List of Proposed Revisions to Part 9 and Attachment G

Testimony-Section III.E

Figure G.6-1

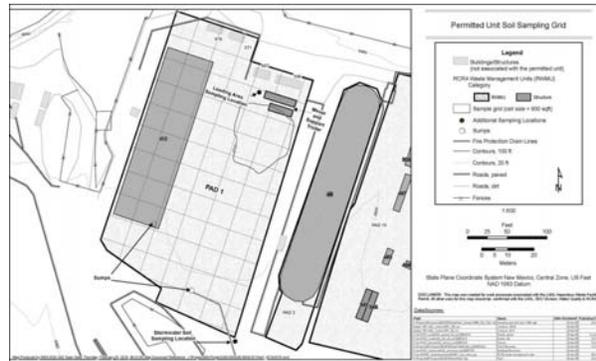
This section of the closure plan provides a description of the permitted unit which is located in the north-eastern portion of Area G and is comprised of an asphalt pad with ~~three structures~~ (Building 412 (the Decontamination and Volume Reduction System (DVRs), ~~the Mobile Visual Examination and Repackaging (MOVER), and support trailer for the MOVER~~) situated on it.

The irregularly-shaped asphalt pad is approximately 358 feet (ft) long and 213 ft wide or approximately 76,000 square feet. The pad, ~~which is sloped 1% to 1.5% to the south and south-east for drainage~~ consists of a four to six inch (in) layer of asphalt over the underlying base course overlying fill (minimum six inches of tuff). ~~The pad has three structures associated with it: Building 412 (DVRs); the MOVER; and the MOVER's support trailer.~~ Storage of mixed waste occurs ~~only on the Pad in Building 412.~~

Dome 226, ~~which was decommissioned in October 2009,~~ was located on the eastern portion of the permitted unit. The dome was approximately 286 ft long and 89 ft wide, was built of an aluminum framework of trusses covered with tension-fitted ultraviolet resistant, fire-retardant coated, polyester fabric anchored with bolts to the pad's concrete ring wall and had a surface area of about 22,300 square ft. The interior floor perimeter of the dome was surrounded with a 6-inch-high, 6-inch-wide asphalt curb and was equipped with personnel doors and a roll-up door on the south end for vehicle access. A ramp was located at the vehicle entrance to the dome, which allowed vehicles and container handling equipment to pass safely over the interior curb which prevented run-on into the dome. At the southern end of the dome was a drain connecting to the recessed sump in Pad 9's Dome 229. This fire protection drain system consists of a 10 in. line running southeast from where Dome 226 was located with secondary connecting drains from Domes 232 and 231. The purpose of this drain system was to provide additional fire water collection capacity in the event of an emergency. The sump and drain have ~~been plugged to prevent storm water from entering the system at the drainage point.~~

Figure G.6-2

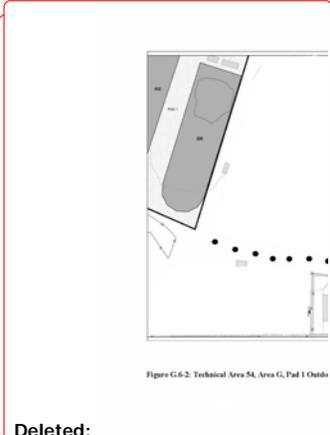
1. if the soil sample collected at the southeast edge of the permitted unit detects hazardous constituents, ten samples shall be collected along the swale between the permitted unit and Pad 10 (see Permit Section 9.4.7.1.ii(8)) (see Figure G.6-2).

1. if the soil sample collected at the rock check dam detects hazardous constituents, ten samples shall be collected along the swale between the permitted unit and Pad 10 (see Permit Section 9.4.7.1.ii(8)) (see Figure G.6-2).

Figure G.11-1

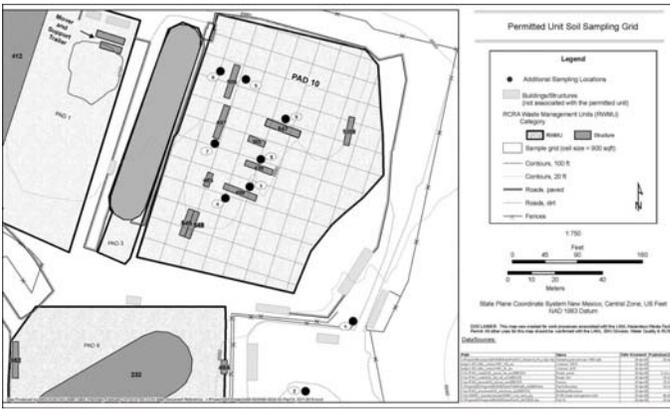
One wipe sample will be collected from each piece of decontaminated equipment at the permitted unit. In compliance with Permit Section 9.4.7.1.i, this closure plan will ensure the collection of at least one wipe sample from each wall, floor, and ceiling of the RTR2, the LANL HENC, the MCS HENC, the SuperHENC, and the two storage trailers (545 and 546) for a total of 36 samples.

Figure G.12-1

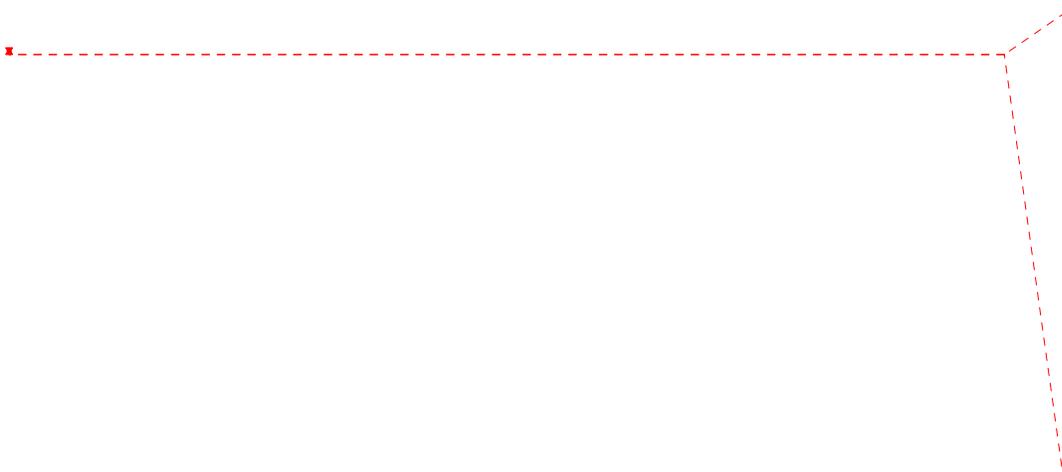
One wipe sample will be collected from each piece of decontaminated equipment related to the permitted unit. In compliance with Permit Section 9.4.7.1.ii.a, this closure plan will ensure the collection of soil samples from the following locations:

Figure G.12-1 illustrates these proposed sampling locations.

Figure G.15-1

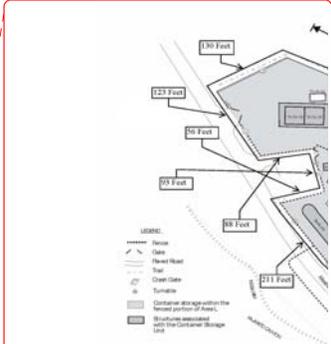
An assessment of the permitted unit's physical condition will be conducted in accordance with Permit Section 9.4.6.2. The assessment will include inspecting the floors, walls, and ceilings of storage buildings 68, 69, and 70, Storage Shed 31, and Building 39, the floors in Dome 215, where Canopy 216 was located, and covered storage pads 32, 35, 36, and 58, and the floor of the permitted unit for any existing cracks or conditions that indicate a potential for release of constituents.
